Amendments to the Drawings

REMARKS

This responds to the Office action dated 8 November 2004. Applicant respectfully requests reconsideration of the application in view of the foregoing amendments and following remarks. Claims 1-3, 5-7, 9, 13, 16, 17, 20, and 23 have been amended. New claims 24 and 25 have been added. Accordingly, claims 1-25 remain pending in the application. Applicant notes that claims, 2, 10, 11, 14, 15, 18, 19, 21, and 22 were not specifically addressed in the Office action. Therefore, Applicant assumes that 2, 10, 11, 14, 15, 18, 19, 21, and 22 are allowable. In addition, Applicant notes that only claims 1, 6-8, and 23 were rejected over the prior art. Accordingly, Applicant presumes that claims 2-5 and 9-22 would be allowable if the § 112 issues are addressed.

Fig. 6

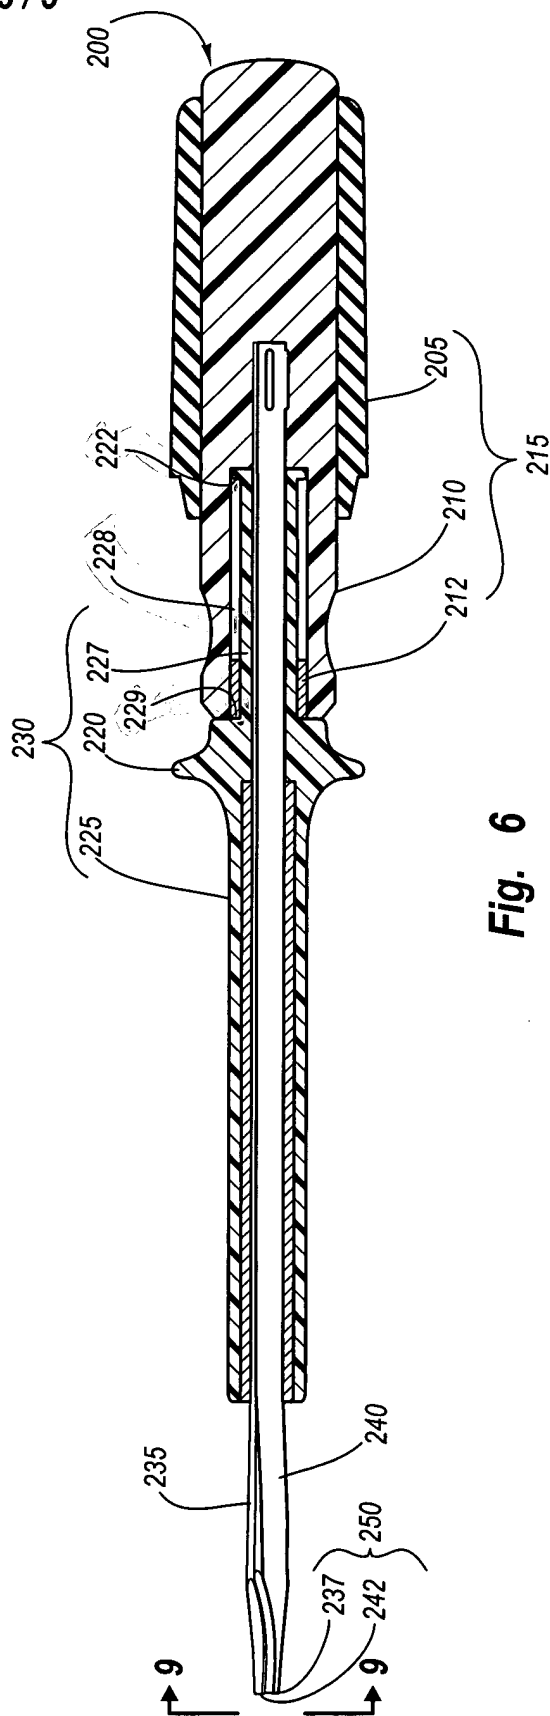
The attached sheet of drawings include changes to Fig. 6 on one (1) sheet. The sheet, which include Figs. 5-6, replaces the original sheet including Figs. 5-6. In Fig. 6, element numbers 222, 228, and 229 have been added.
